- 1.1 WYG has been appointed by Ingham and Yorke on behalf of their client, Mr M. Fisher and Dr G. Fisher, to provide traffic and transport advice regarding the Teewood Farm barns, Waddington proposals.

- 1.4 The site layout, including the form of access and visibility splays is shown in WYG drawing A108315-SK01-P02, provided as **Plan 2**.
- 1.5 The purpose of this Technical Note (TN) is to appraise the Local Highway Authority (LHA), Lancashire County Council (LCC), of the benefits of the new access arrangements.

Appendix A – Correspondence with Lancashire County Council

Plan 2 – WYG Drawing A108315-SK01-P02

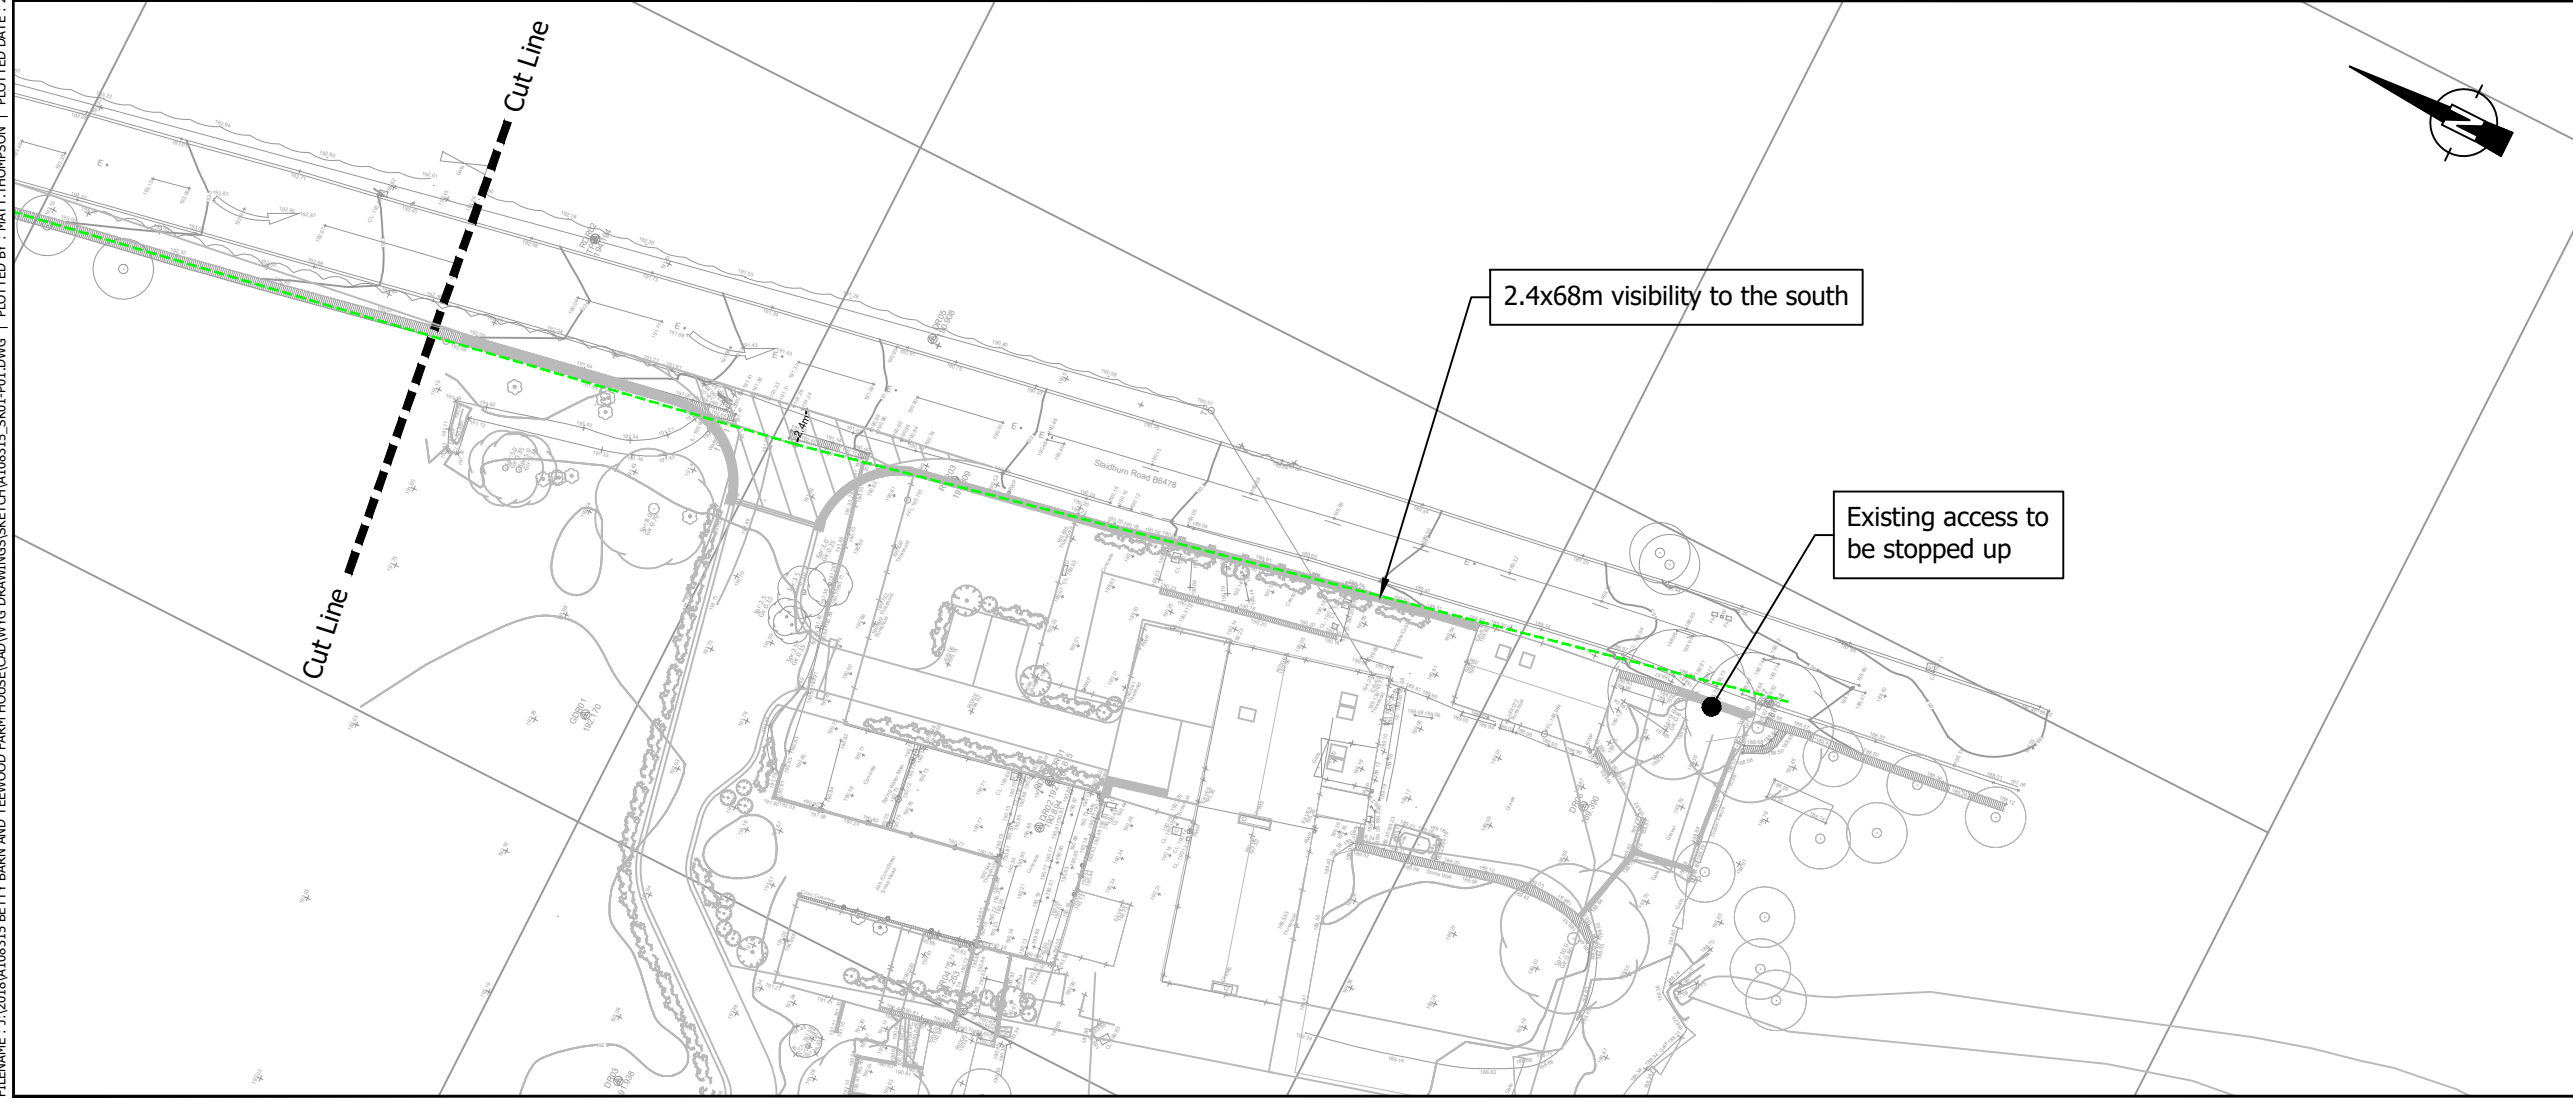
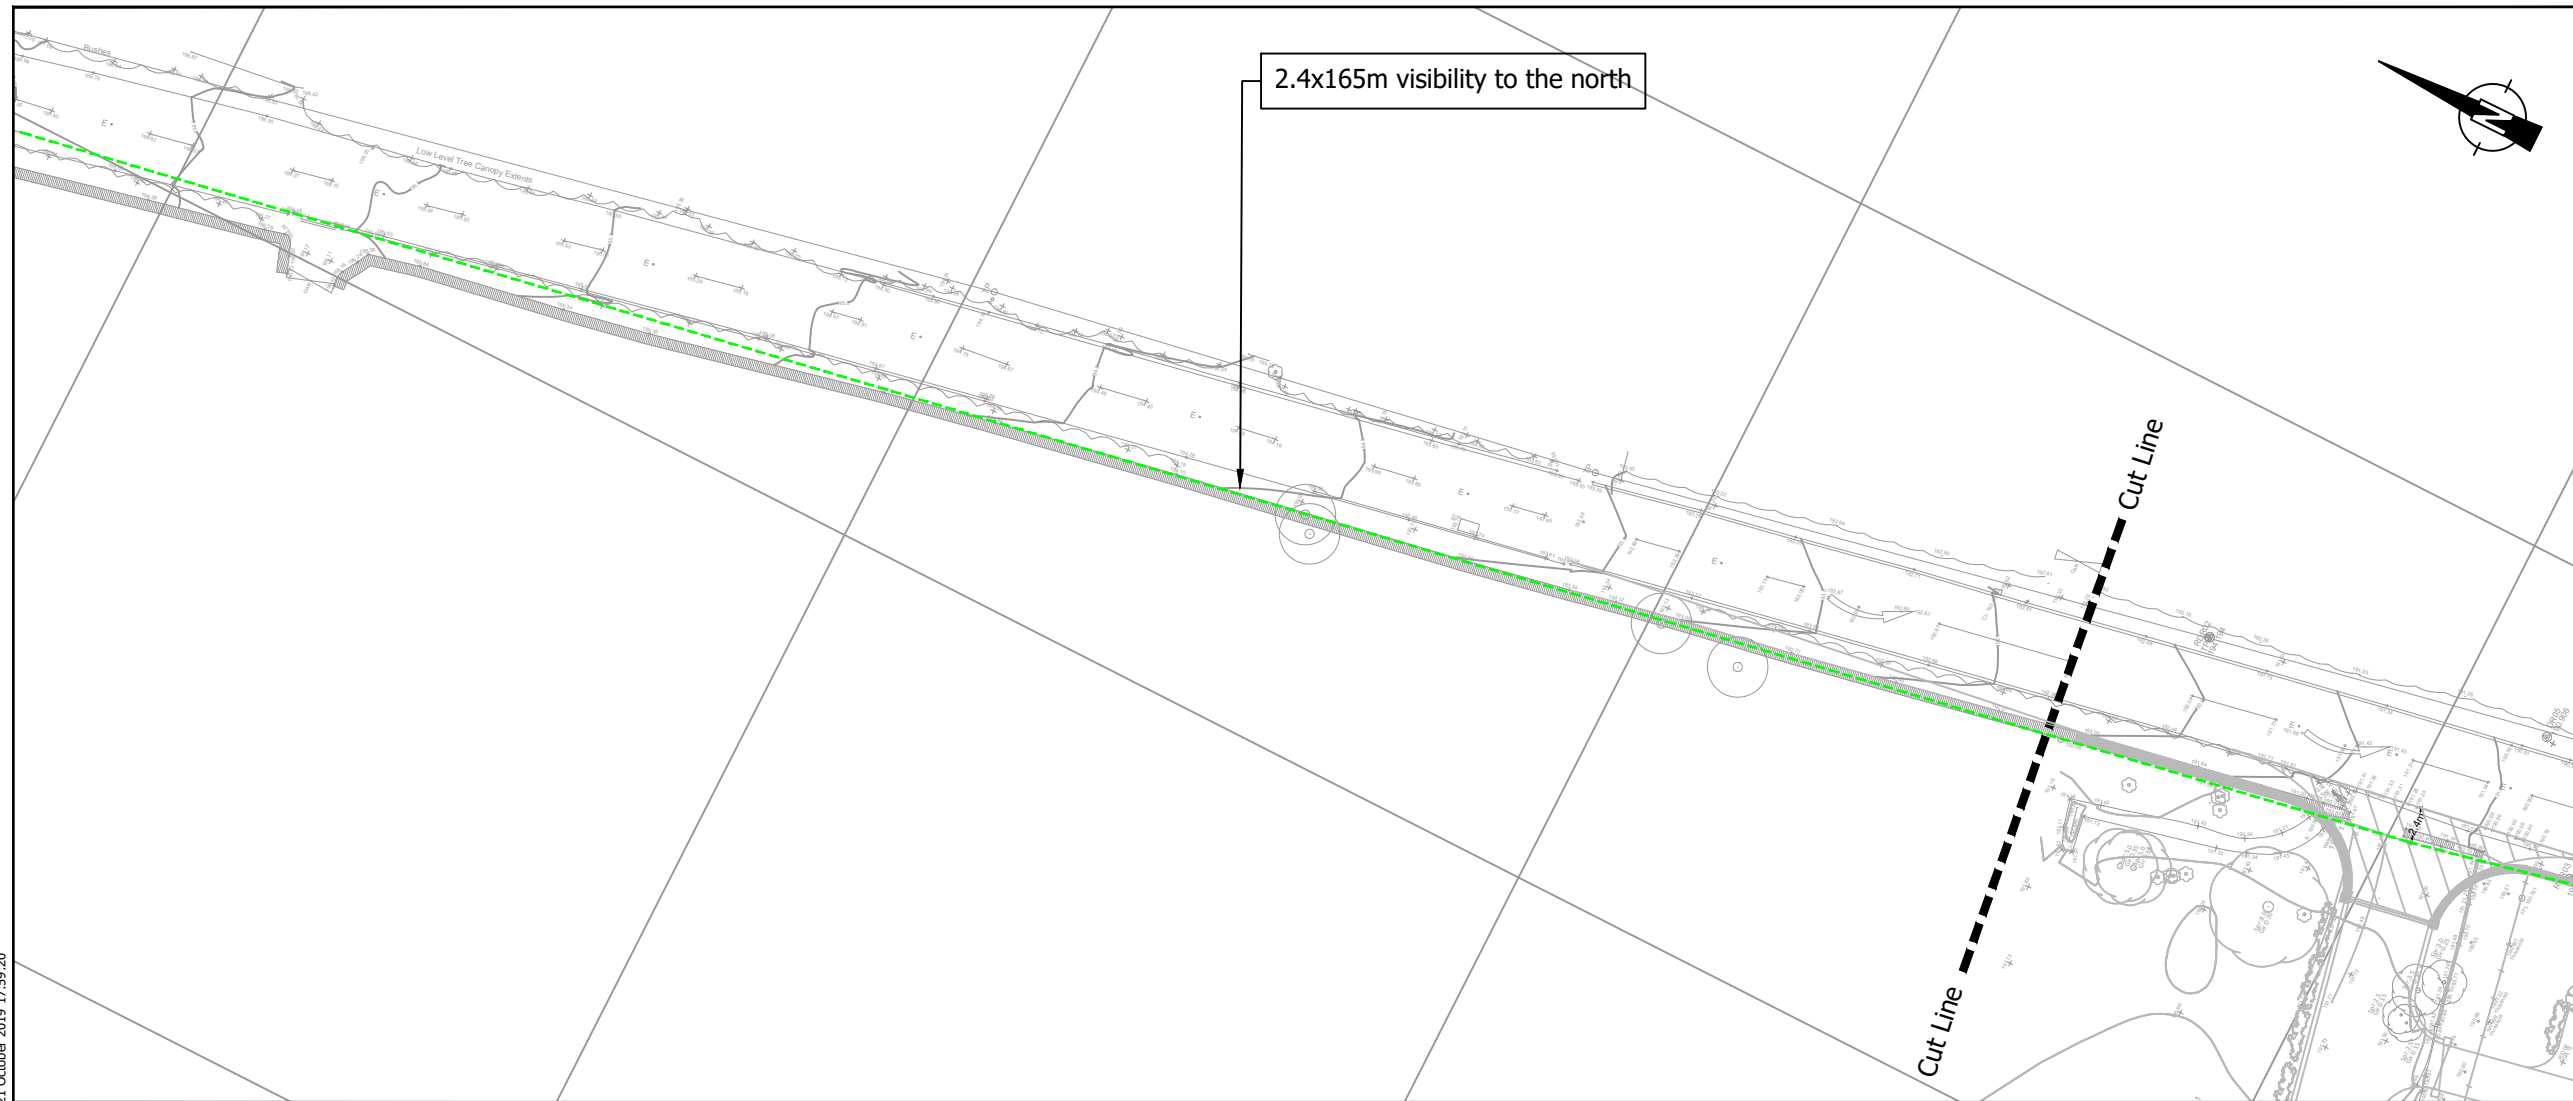
As promised I have now had the opportunity to visit the sites and it is apparent that the existing access points are substandard and offer poor visibility. Dealing with each of the sites in turn I would make the following comments

The new access would improve the visibility for the existing residential developments served from this access and as such it would be supported. As with the previous case, I would require a similar access treatment. The existing access should be permanently closed to all traffic and walled.

With both cases, I would be looking at the overall improvement offered over the existing provision and as such it may not be necessary to adhere to the visibility splay guidance as appropriate for the prevailing 85th%ile speeds but this is not to say that the visibility should not be maximised, within reason, to the best achievable.

in the meantime can you confirm that the existing access points will be permanently closed. There is nothing on the plans to show that this is to be the case. In the case of Betty Barn , Hollin Farm share the access and their agreement will be required.

- 2.5 LCC provided advice on the required width and extent of surfacing of the new proposed access. It was agreed that the access will be capable of accommodating two-way traffic at the entrance. Suitable surfacing will be provided for 7m into the site at which point it will tie into a new farm track.
- 2.6 LCC also required that the existing access junction be stopped up.

NB: the existing access could be used as inbound only, but the applicant has agreed to stop it up in this case. Whilst a case could arguably be made that intensifying the existing sub-standard junction by adding one more property’s traffic would not be a material change, the applicant has instead taken the view to significantly improve the access and egress which will also benefit the existing access users, by promoting a new access proposal as illustrated on **Plan 2**.

- 3.5 The proposed access lateral visibility of 2.4x165m to the north and 2.4x68m to the south is a significant improvement for both new and existing users of the access.
